PG&E Letter No. DCL-90-050

Supplemental Information for Permit Renewal Application  
Diablo Canyon Power Plant - NPDES No. CA0003751

ENCLOSURE 1

Attachment C  
WASTE STREAM SCHEMATIC

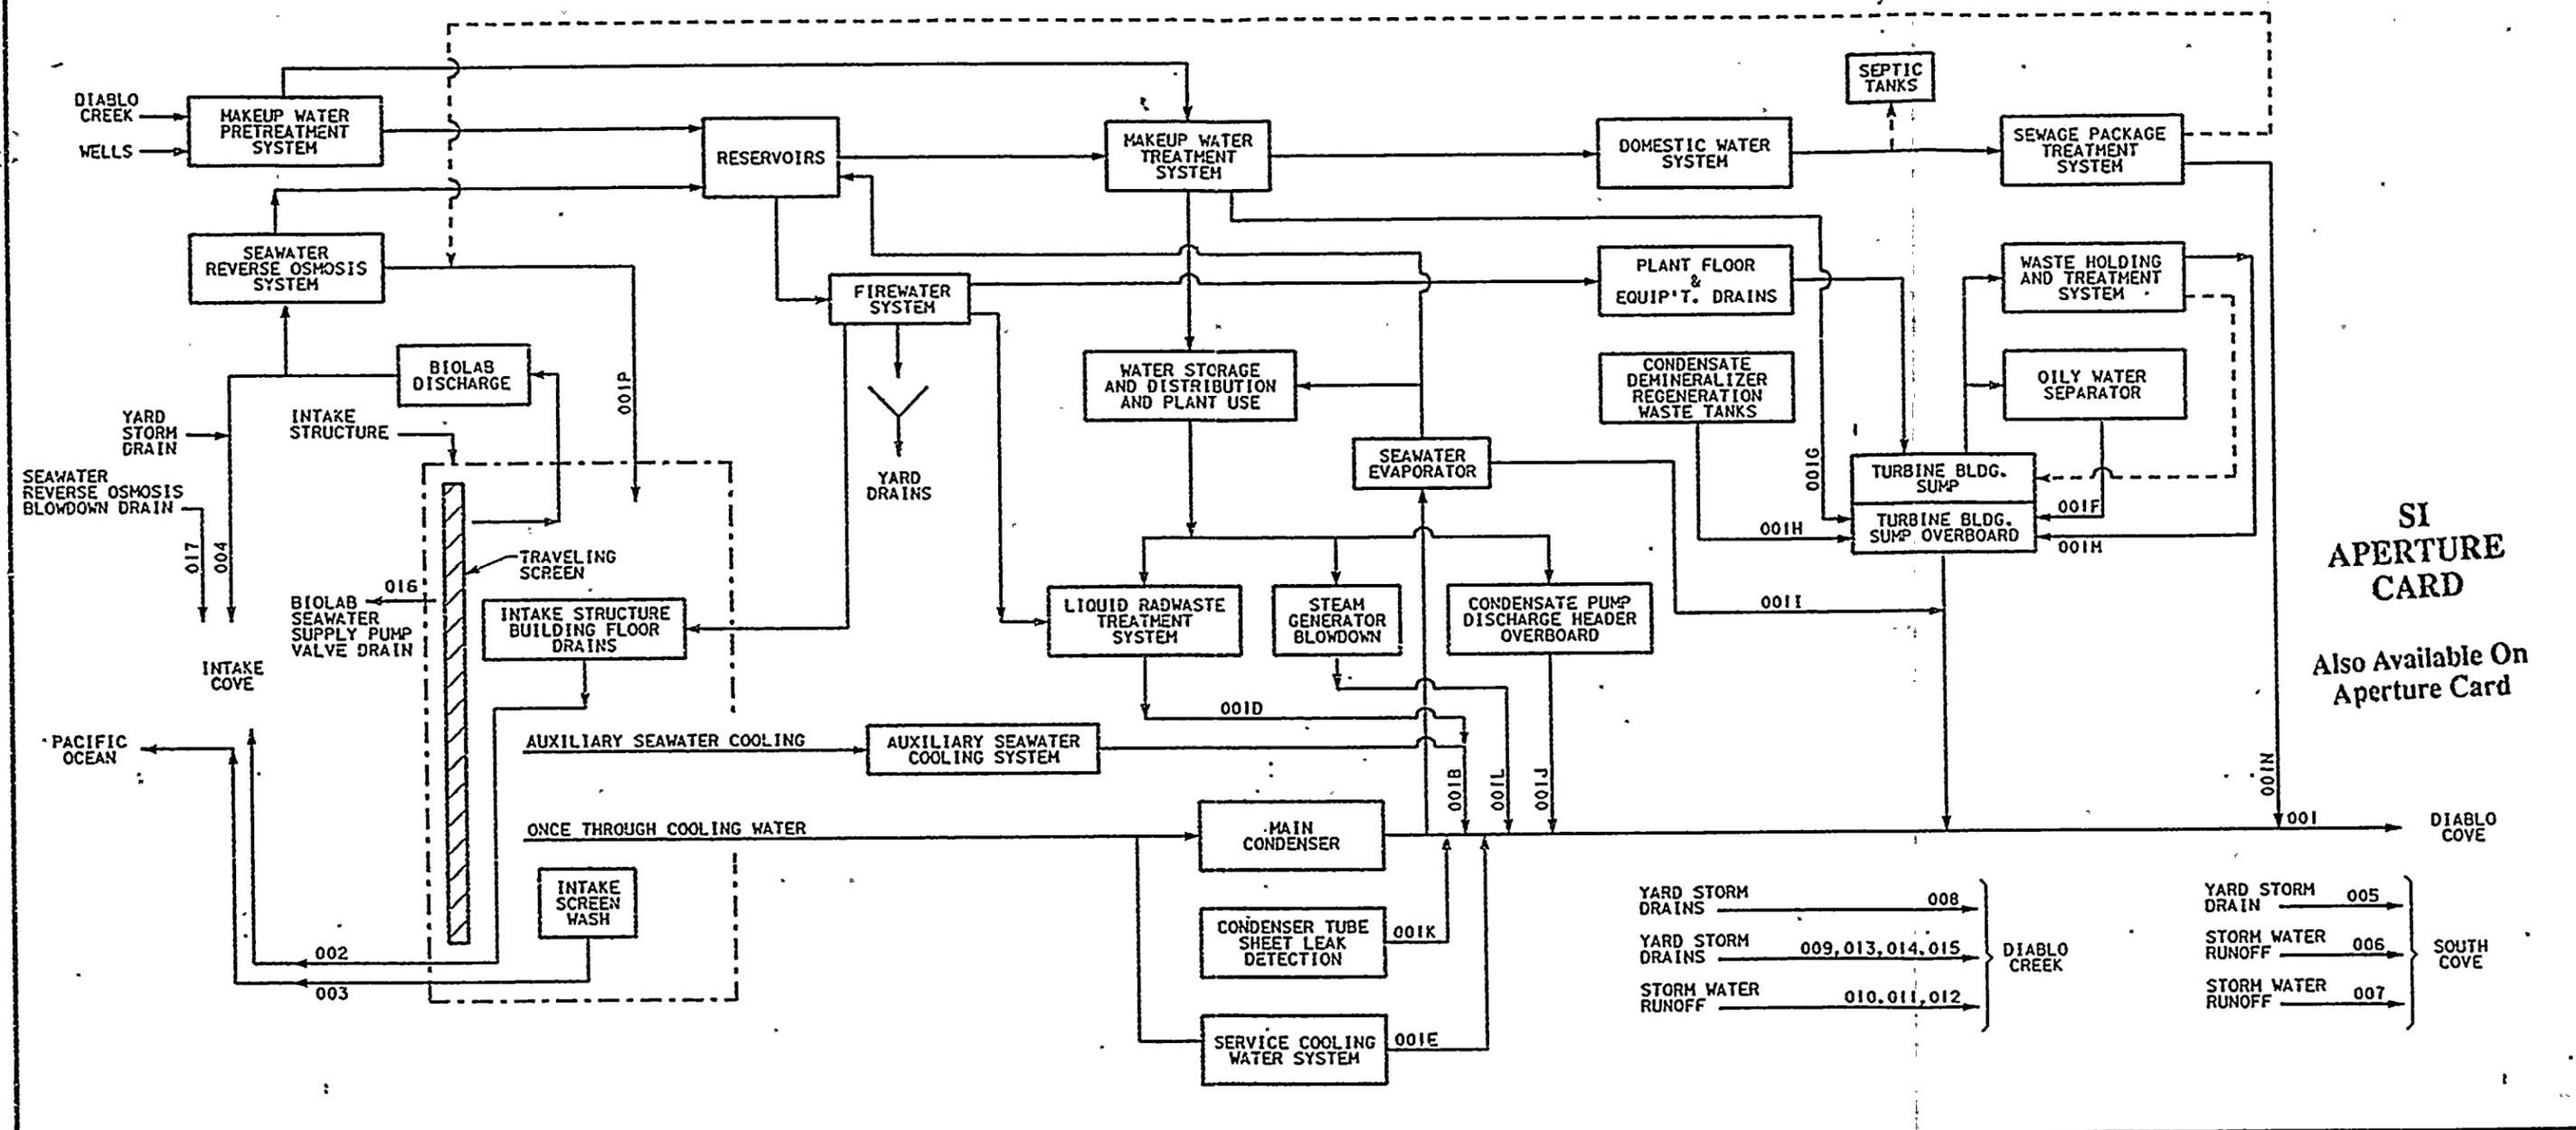
- Discharge 015 - Flotation and landfill have been added to treatment descriptions based on the use of an oil/water separator.  
Tab-4
- Attachment C - Waste Stream Schematic. The operation titles have been revised as stated above.  
Tab-5
